WORK DESCRIPTION FOR FIELD MEASURE

Code: 19P8891002

Replace rear apron and perform SCN coding in rear switch module control unit

Model 290

Figure 1

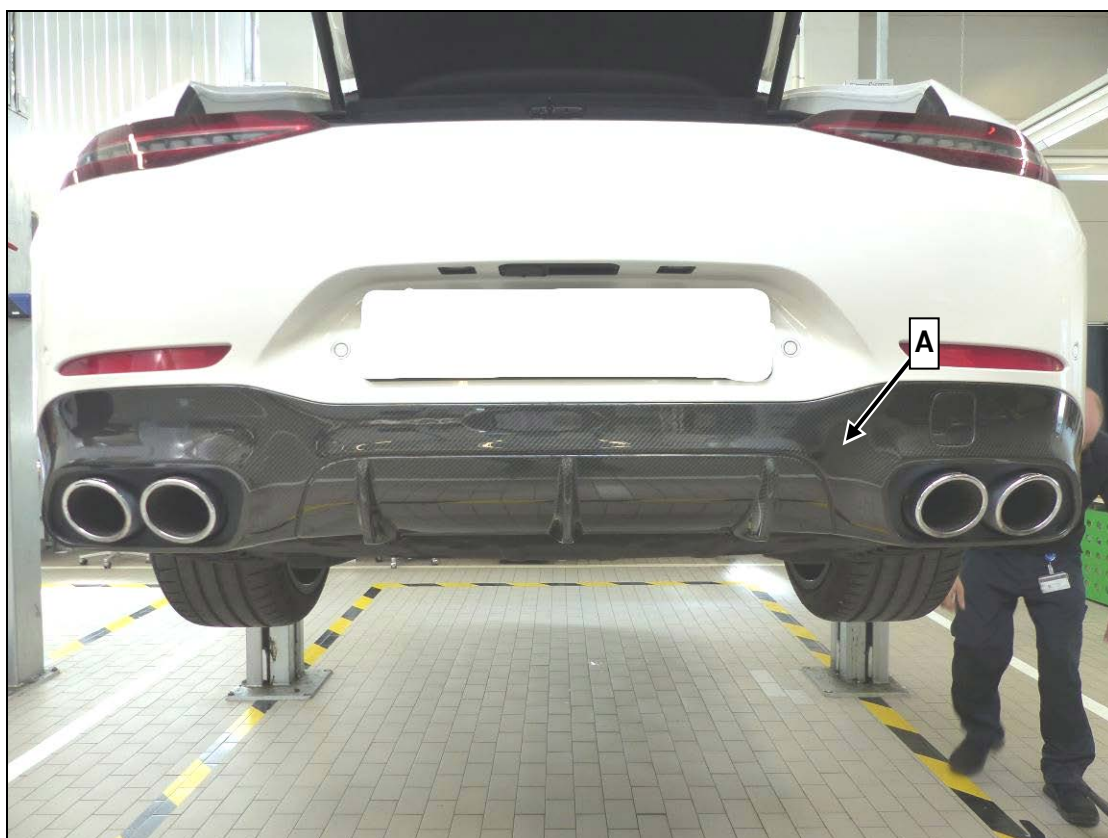
1. Replace rear apron (A, figure 1 (bumper lower section)).
